Athletic Field

Cheverus High School

RE: Cheverus High School, 267 Ocean Avenue

On June 10, 1997, the Portland Planning Board considered several amendments to the 1989 conditional use and site plan approvals for the Cheverus High School Athletic Facility.

PROJECT NO. 97.117-00 DRAWING NO. **SD-1**

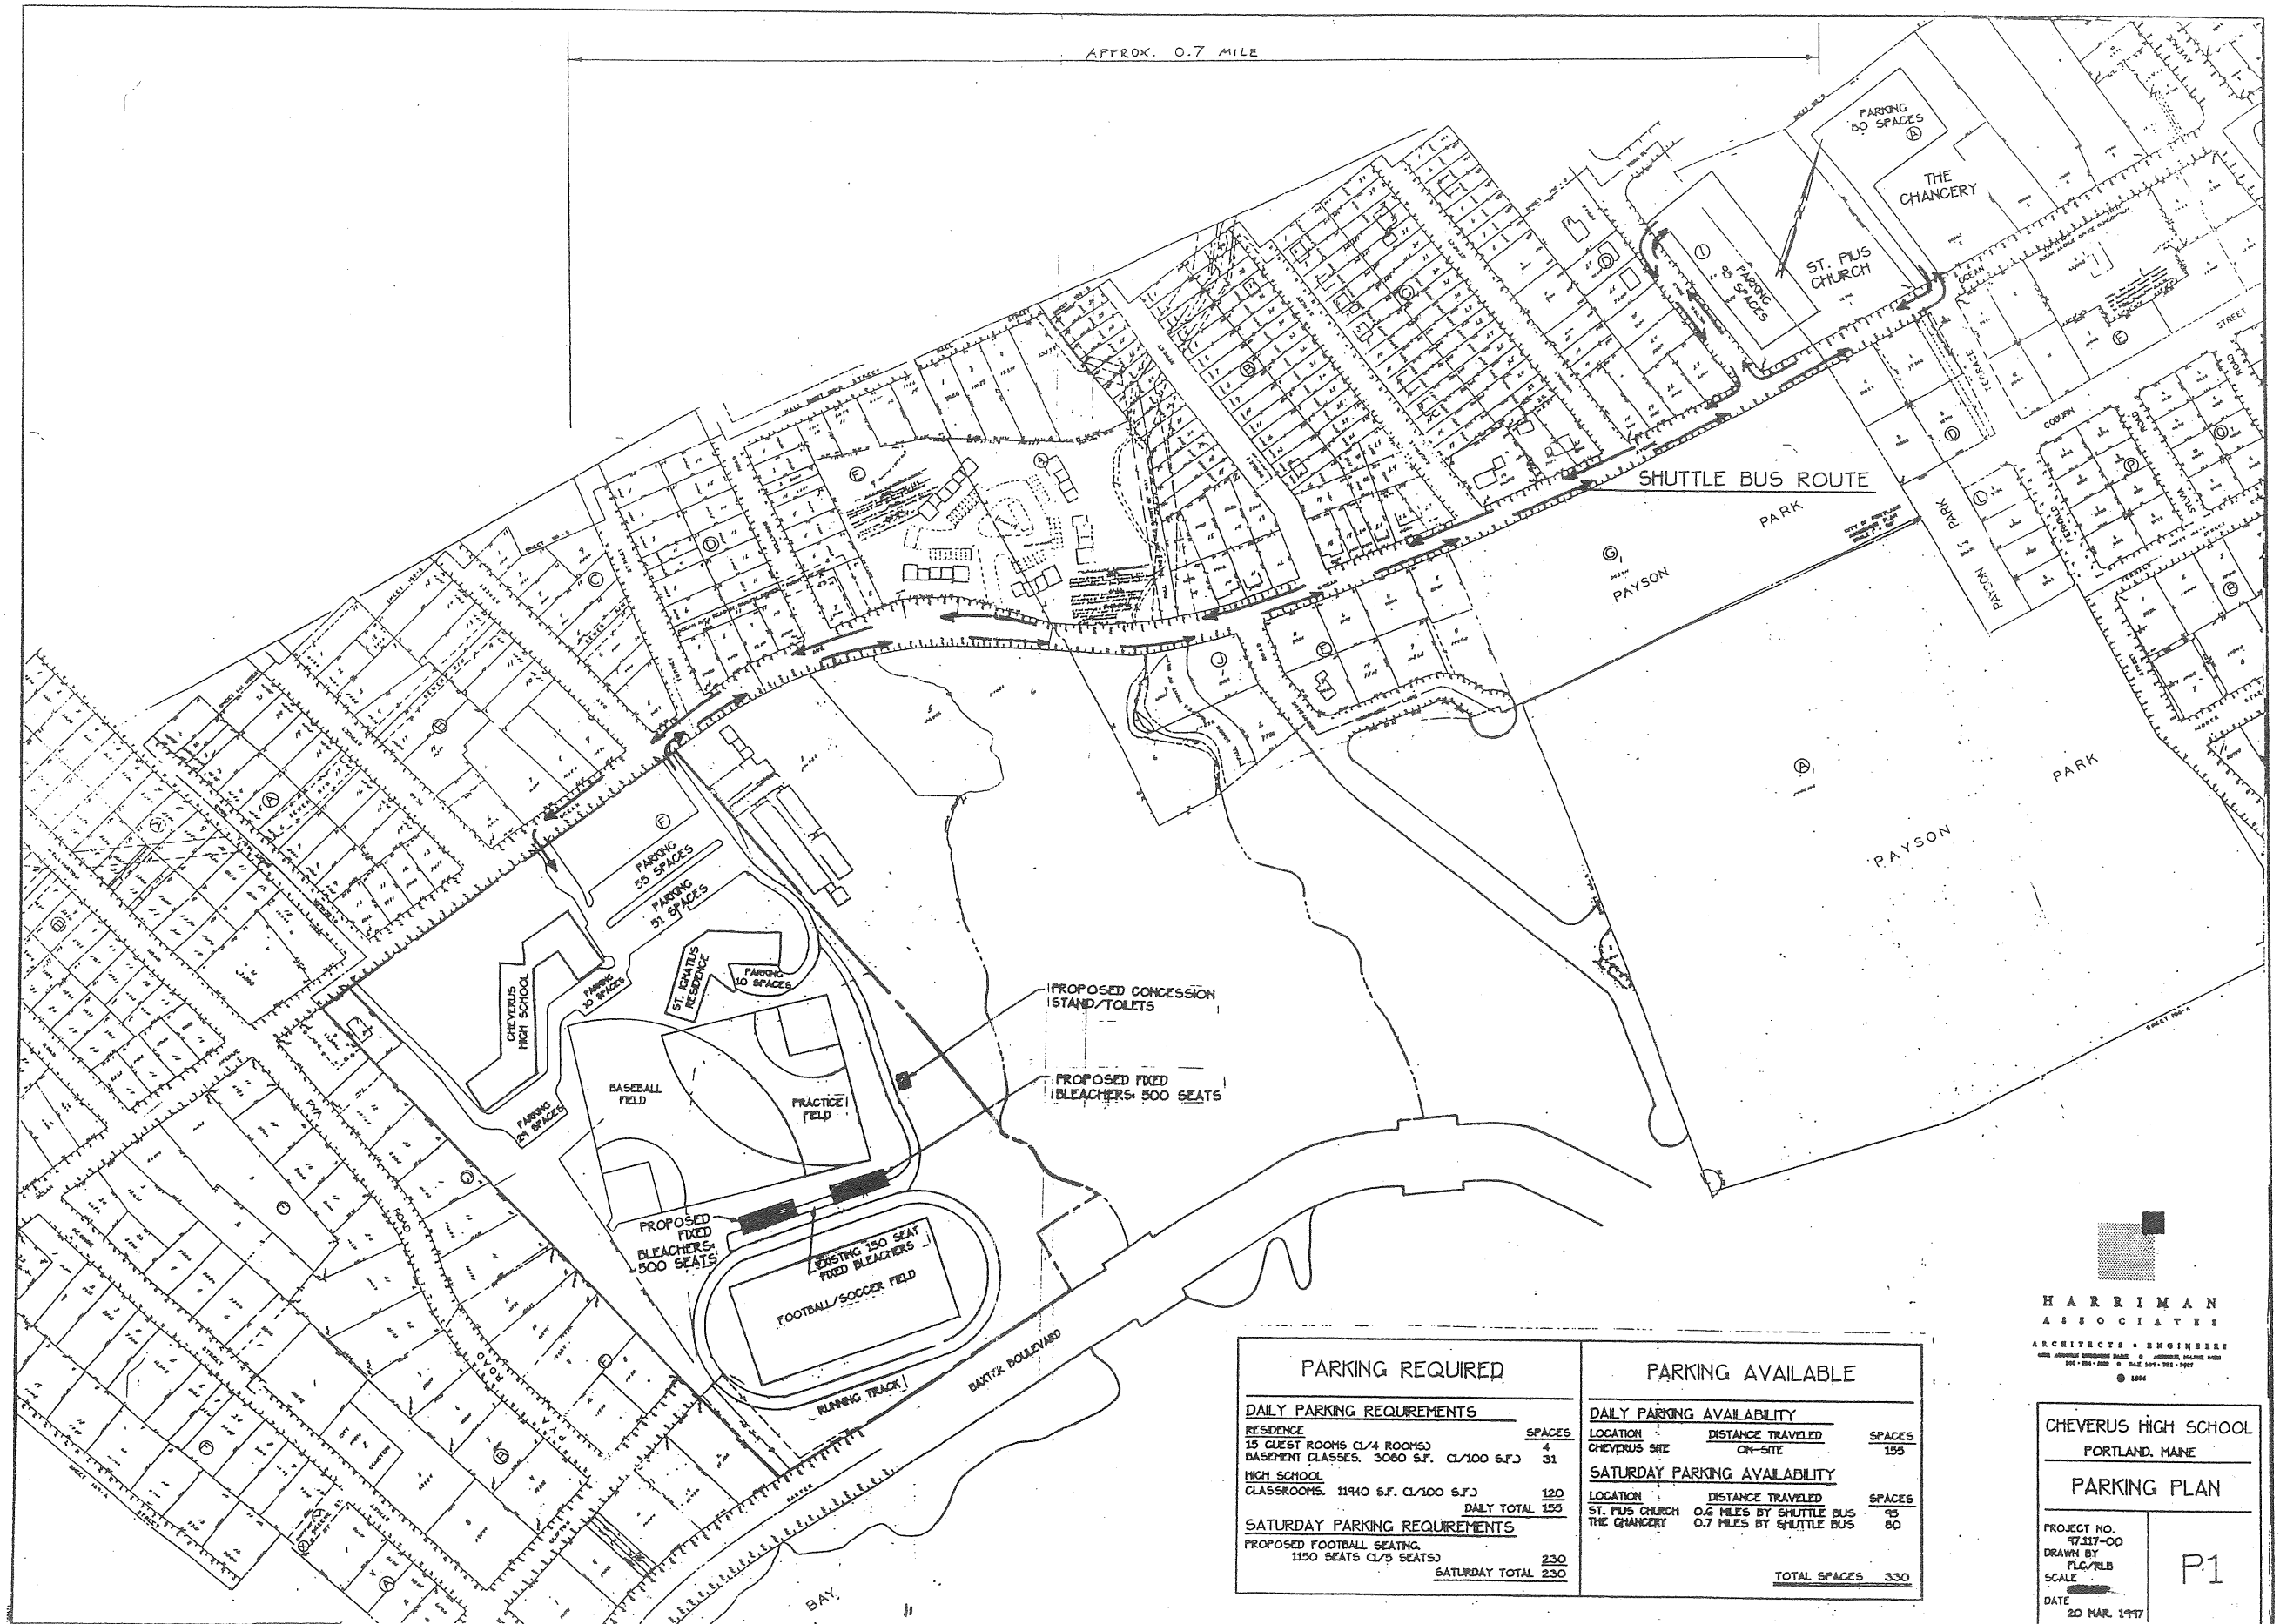
- i. That the plan be revised indicating a water line and sewer line to the concession stand/restroom for staff review and approval.
 - ii. That the site plan be revised indicating sod material to stabilize the slope area disturbed by the bleacher installation for staff review and approval.

- Indicate utilities to the press box, scoreboard and concession stand. Will the power lines be underground?
- The proposed bleacher cross-section indicates that erosion control mesh will be used. Please be more specific on what type of material will be used and how will it be secured into the slopes, etc. Given the steepness of the slope, it may be advisable to use sod unless you can provide more details on the proposed erosion control measures.
- Please indicate the shoreline setback of the concession stand. It will need to be a minimum 75 feet from the shoreline below.
- Sheet P1. The "saturday parking requirements" should be modified to include the appropriate number of seats not the 1150 seat figure.
